**Project: South Battery Park City Resiliency Project:  
Pier A Plaza / Battery Site Work And Near  
Surface Isolation (“NSI”) Construction Services  
(the “Project”) Request for Proposals (“RFP”)**

**Date: January 27, 2023**

**RE: Addendum #6  
# of Pages: 69**

C-223.00

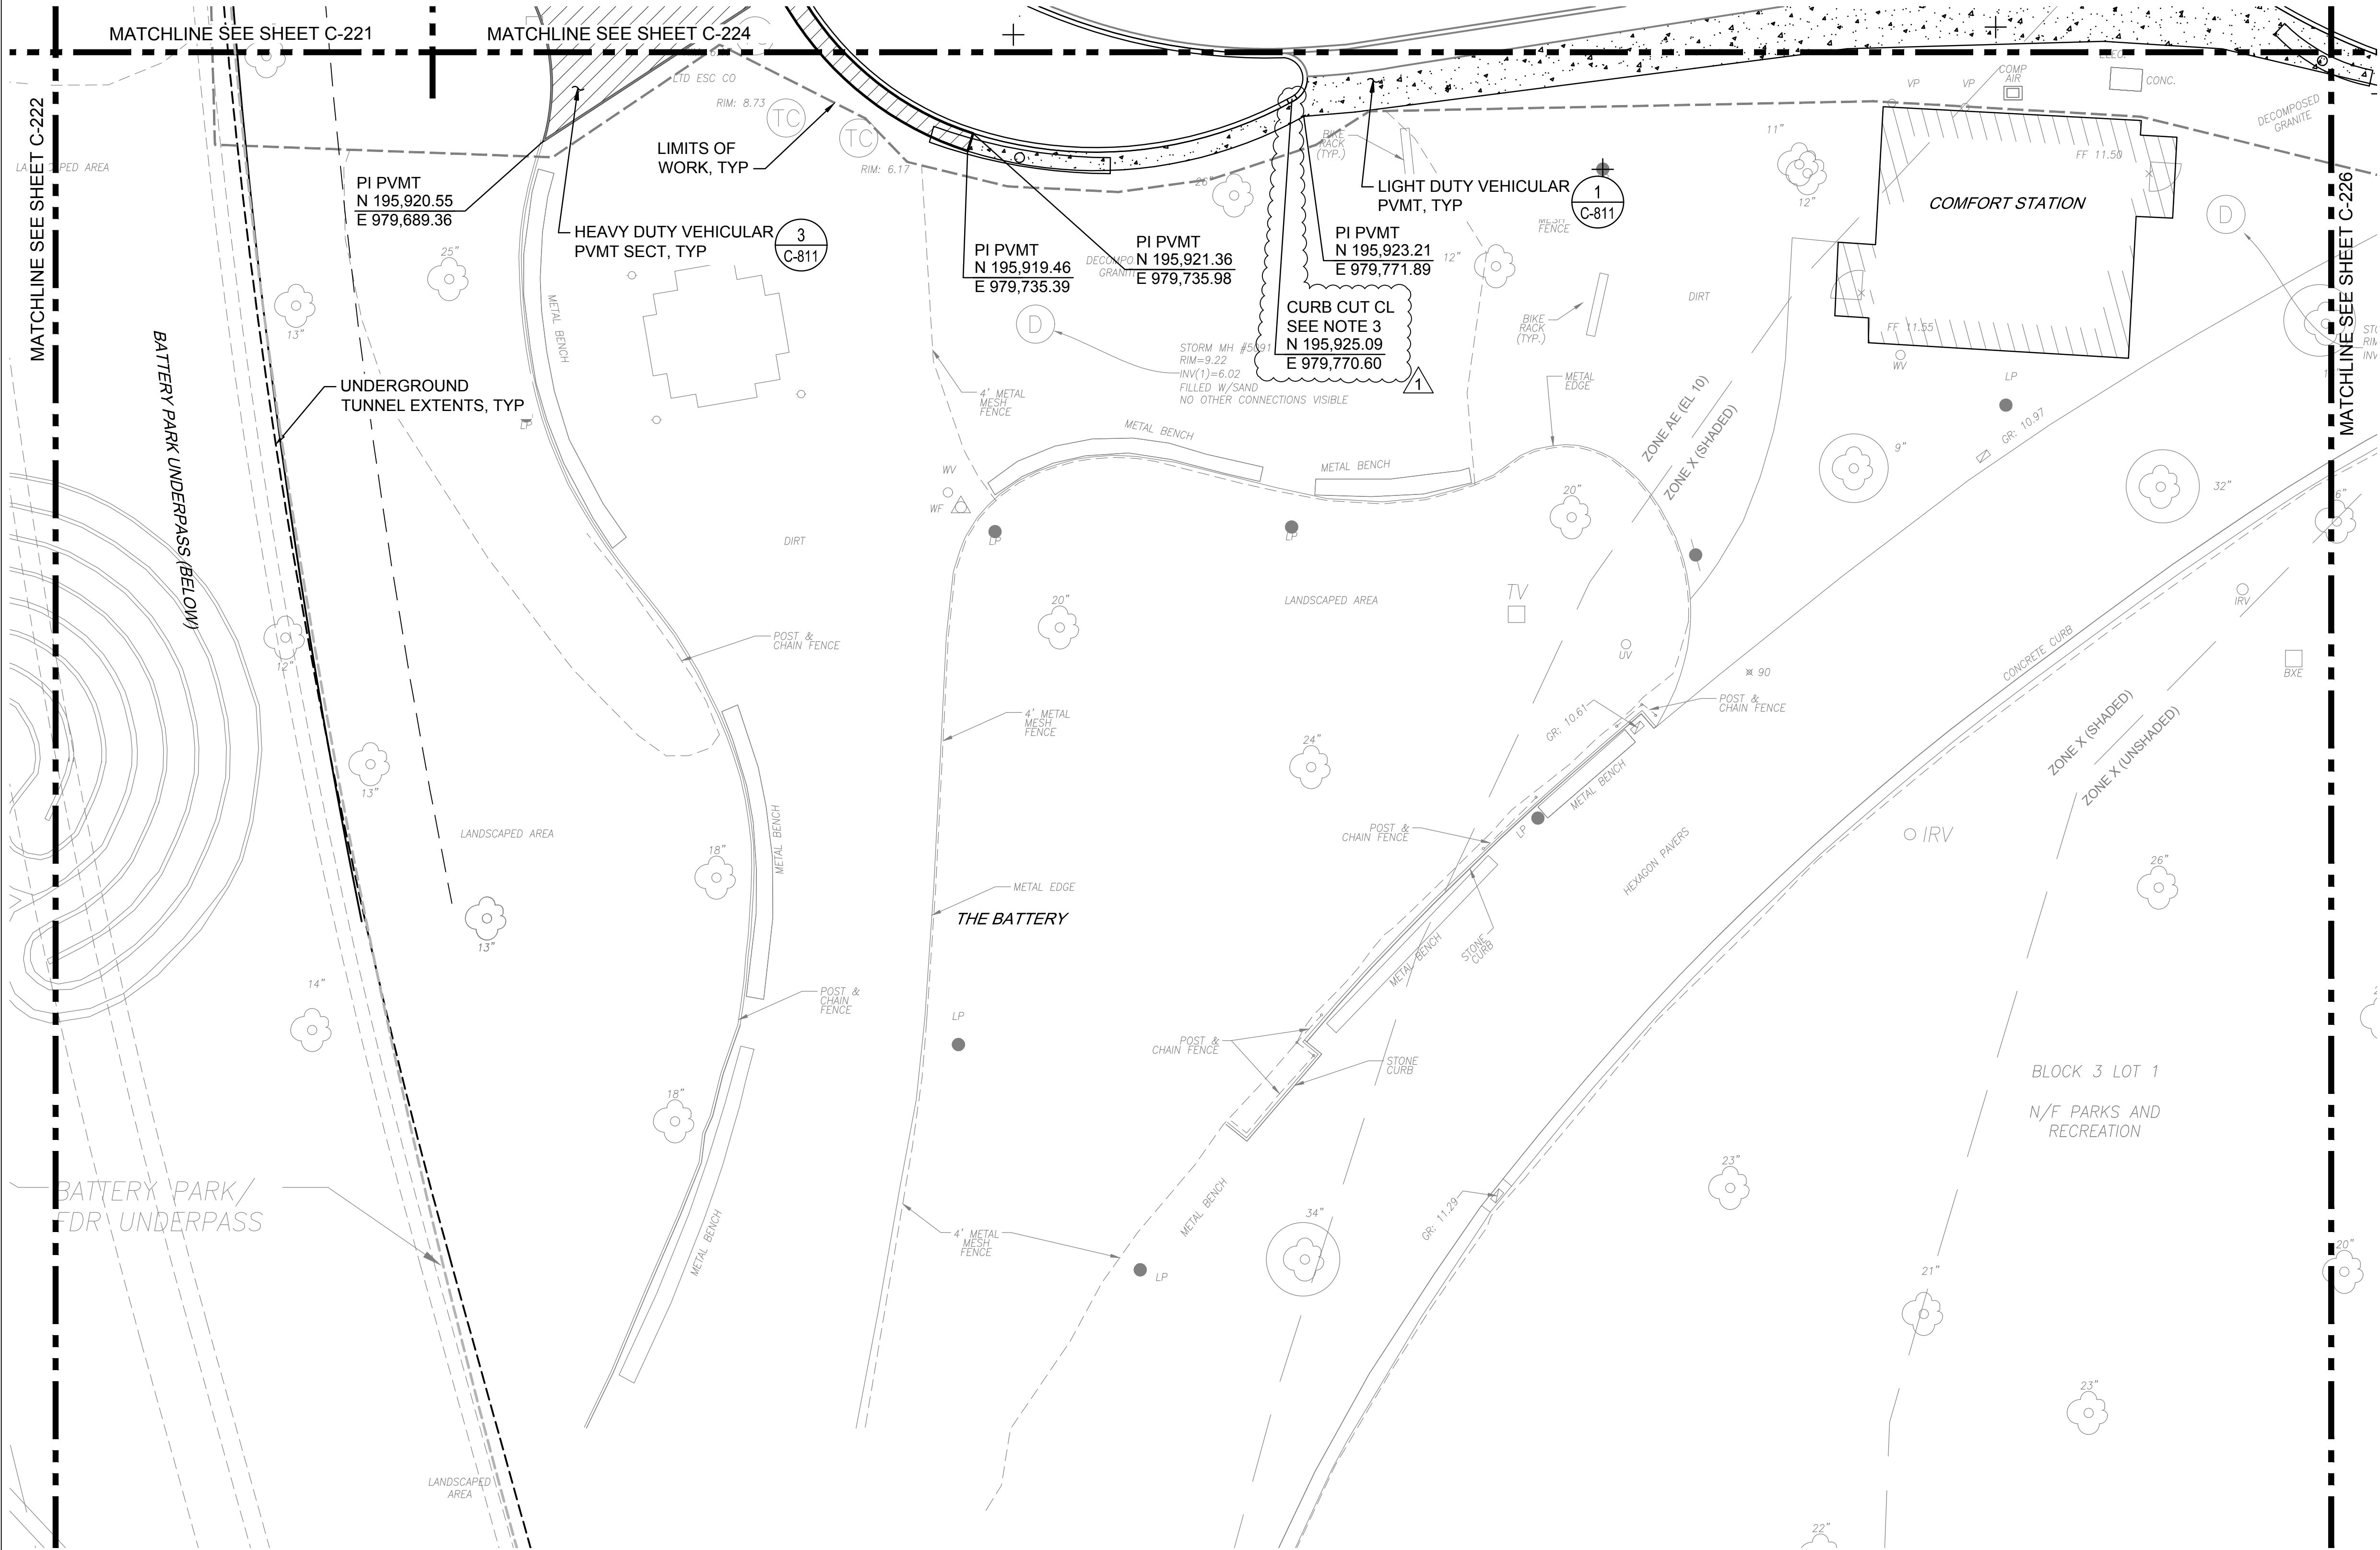
- 57) On Multiple sheets there are Curb Cuts called out as being NYCDPR Specs Detail 6 on 146-R9. Could you provide us with a sheet, because detail 6 on the curb sheets is not for a curb cut.

***The curb cut call-outs on the relevant Civil Drawings have been modified to not reference the NYCDPR standard detail. As noted in Section A – REVISIONS TO RFP (above), revised versions of Drawings C223, C224, C225, C227, C324, C423, and C424 are provided as Attachment #2.***

- CONSTRUCT CURB CUT FLUSH WITH HARDSCAPE SURFACE BY INSTALLING ONE (1) 4" X 8" X 12" GRANITE BLOCK IN LIEU OF 4" X 12" X 12" BLOCK.

**C** TYPICAL WATERTIGHT ACCESS HATCH DETAIL

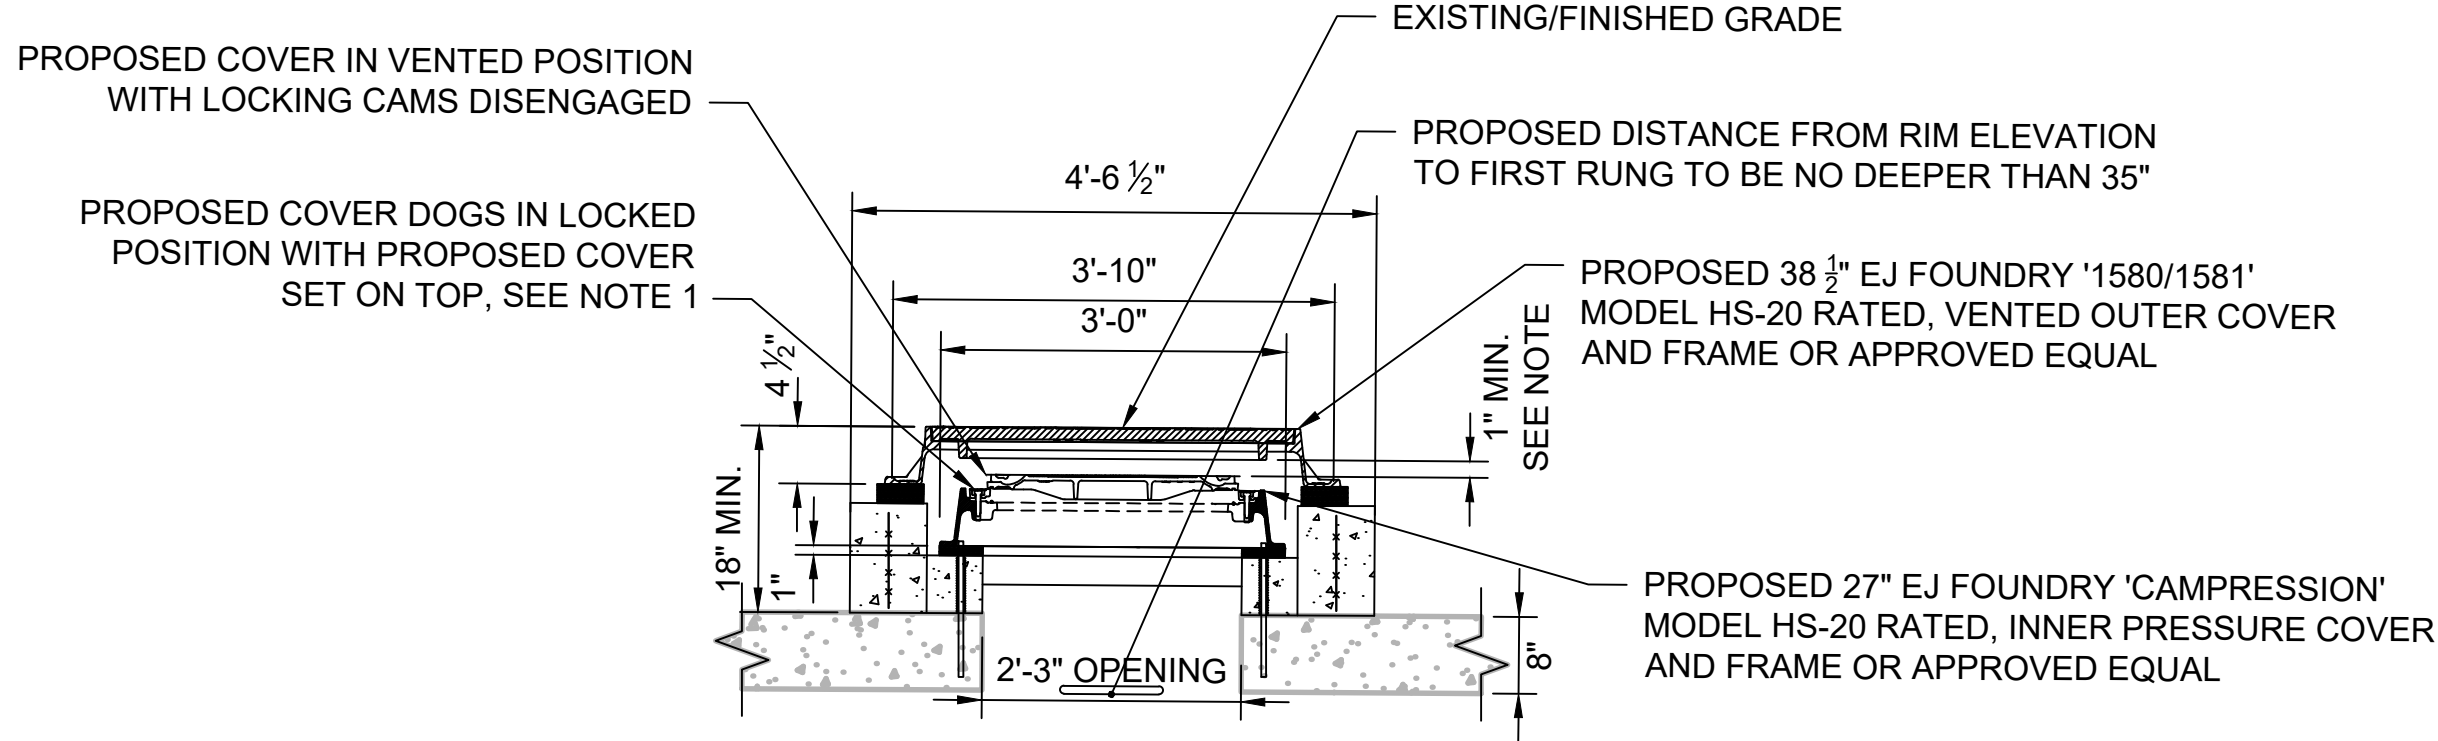
- 17) Please provide a specification for the manual watertight access hatches, or a list of qualified manufacturers.  
***The qualified manufacturers as well as the model type are Walz & Krenzer Model WTH-F or Presray Model D3HA or approved equal (see Typical Watertight Access Hatch Detail on revised***

***Drawing NS003). Please note that the details for the access hatches are revised on Drawing NS003 to include a removable safety grating – which, as noted in Section A – REVISIONS TO RFP (above), is included as part of Attachment #3.***

***Please refer to Detail C on Drawing NS003 which identifies two pre-approved models or approved equal. As noted in Section A – REVISIONS TO RFP (above), specifications for the two pre-approved manual watertight hatch models are provided for reference as Attachments #12 and 13, respectively.***

1. FOR HATCH SIZES SEE SHEET NOS. NS103, NS203, NS303, AND NS403.
2. CONTRACTOR TO FURNISH AND INSTALL REMOVABLE SAFETY GRATING AT ALL WATERTIGHT HATCH LOCATIONS. COORDINATE REQUIREMENTS WITH NYCDEP PRIOR TO FABRICATION.
3. CONTRACTOR TO ENGAGE FABRICATOR FOR FINAL DESIGN AND SHOP DRAWINGS OF HATCHES. PROVIDE SHOP DRAWINGS TO ENGINEER FOR REVIEW AND APPROVAL.
4. ALLOWABLE LEAKAGE RATE TO BE 0.1 GPM/FT OF HATCH PERIMETER.
5. HATCHES ARE TO BE DESIGNED FOR THE FOLLOWING HYDROSTATIC LOADS IN THE UNSEATING DIRECTION:

**FLOOD WALL FOUNDATION**  
**PLAN 4 OF 5**

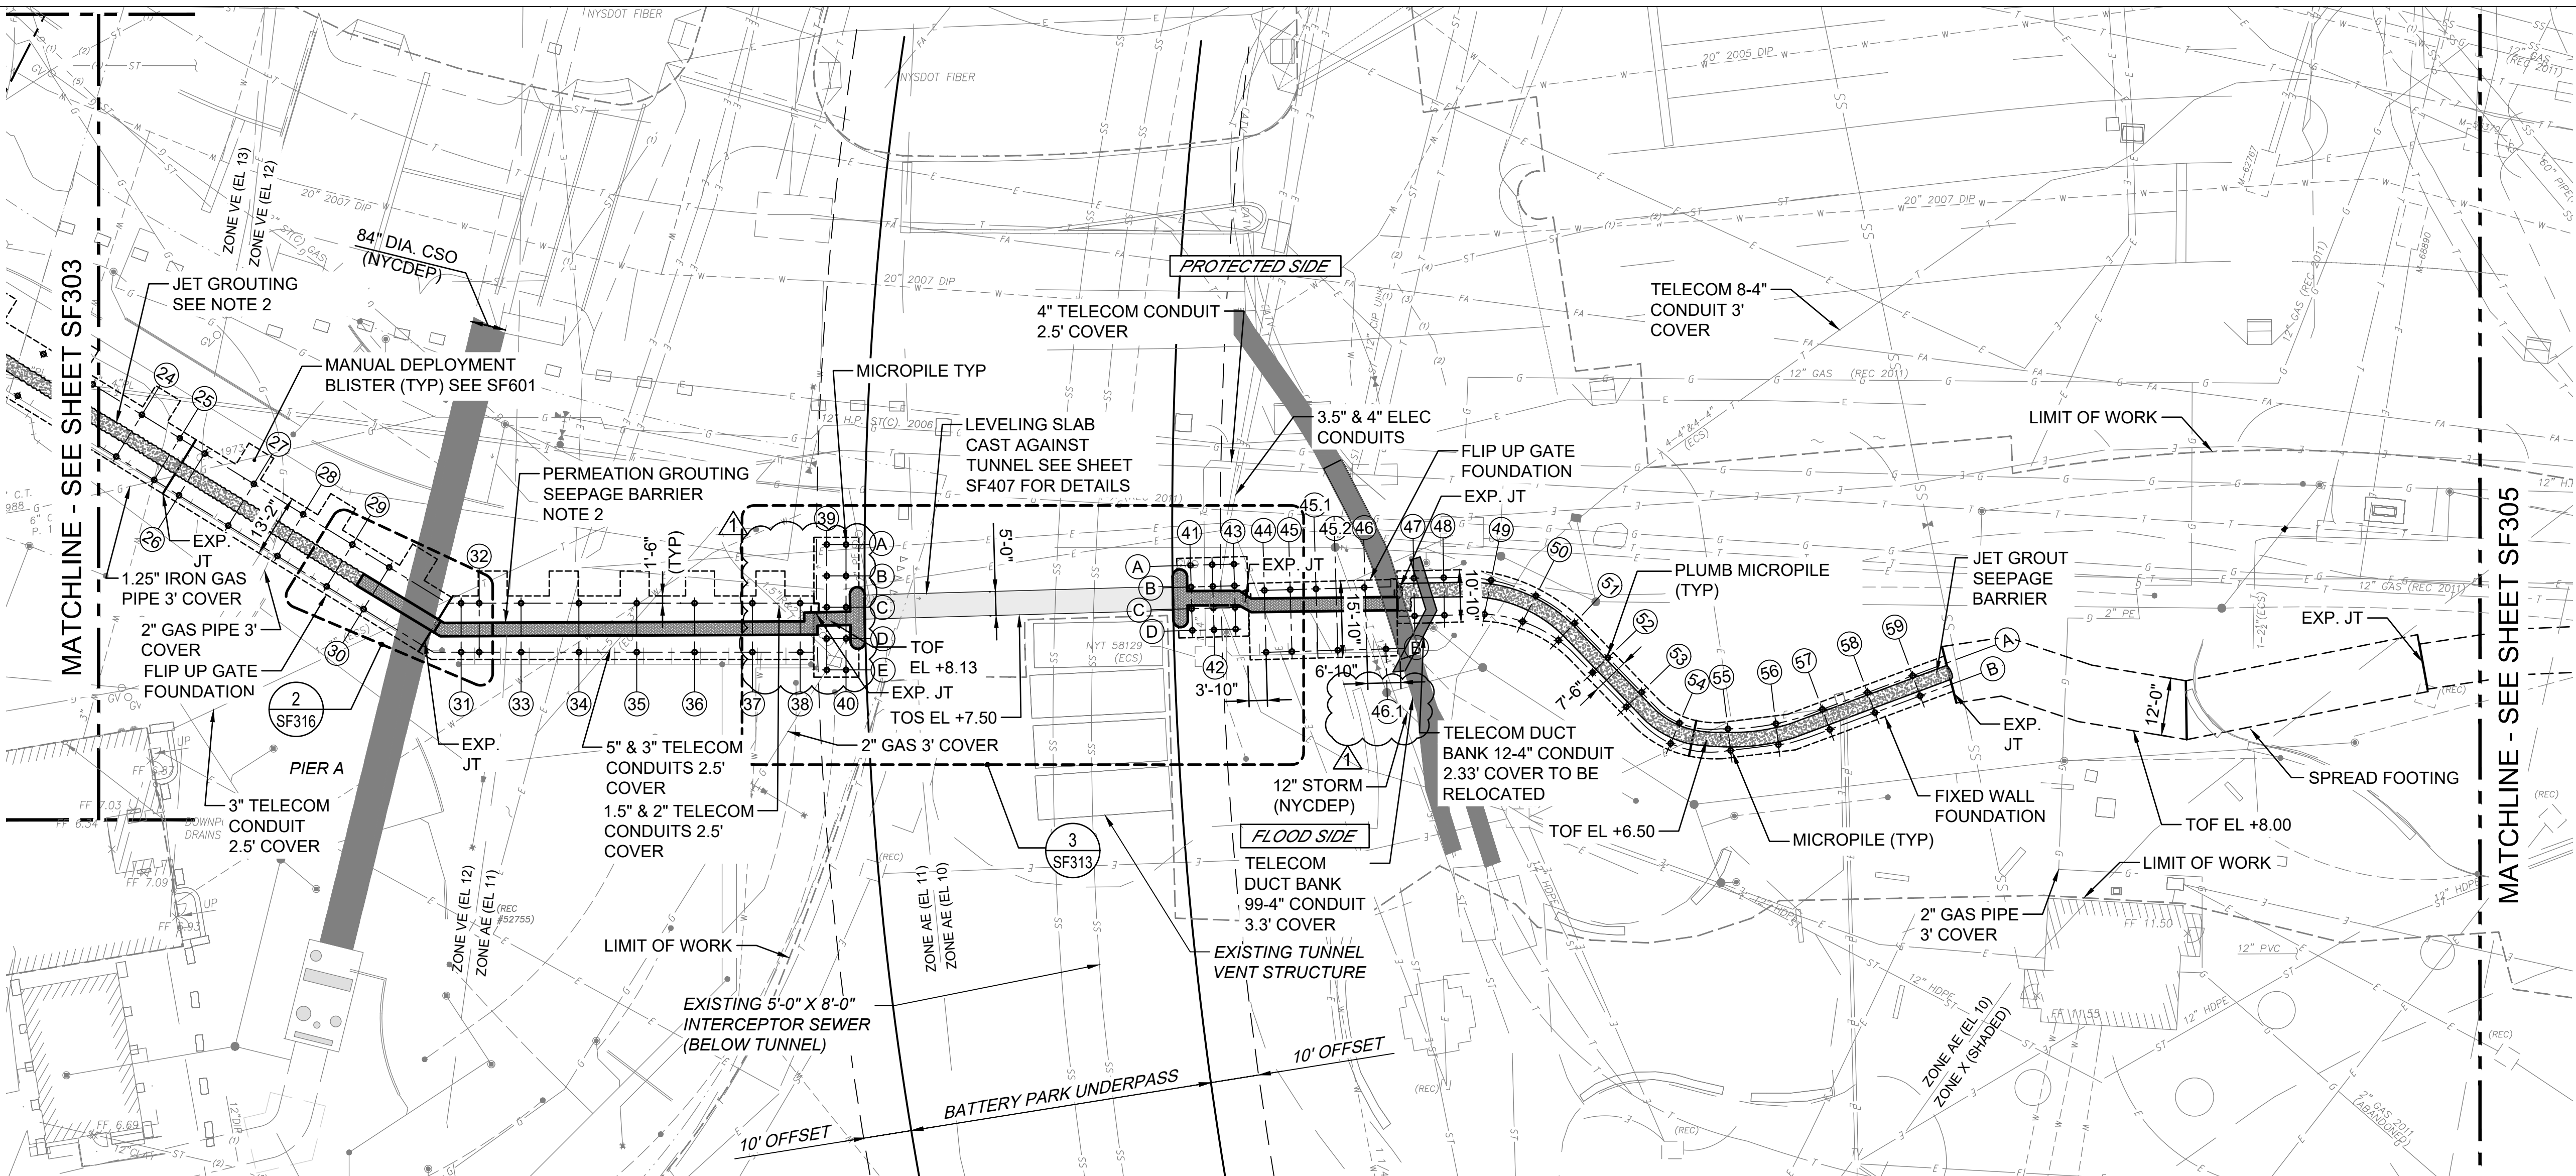
- 40) The quantity of micropiles on plans do not match the quantity of micropiles shown on the tables (Plan SF303 and SF304). Please clarified which quantity controls?

- 45) Ref. Drawing SF304 - This Drawing provides the Northing and Easting information of piles and piles layout, but this is a conflict between the provided table and the flood foundation plan. For example in the table the information provided was for piles No 45A and 45B; Total of 02 piles but on the plan there are total of 03 piles along grid lines 45, 45.1 and 45.2 respectively, please advise.

***The quantity shown on the plans controls. Following Contract award, the selected Proposer will be given access to the CAD files to determine exact pile locations in cases where such locations are not provided in the tables. As noted in Section A – REVISIONS TO RFP (above), revised Drawing SF304 containing a modified table, revised to match the plans, is provided as Attachment #4.***

**The quantity shown on the plans controls, so the bid quantity shall be based on the number of piles shown on the plans. The table is provided for reference only. See response to Question #40 regarding the provision of CAD files to the selected Proposer.**
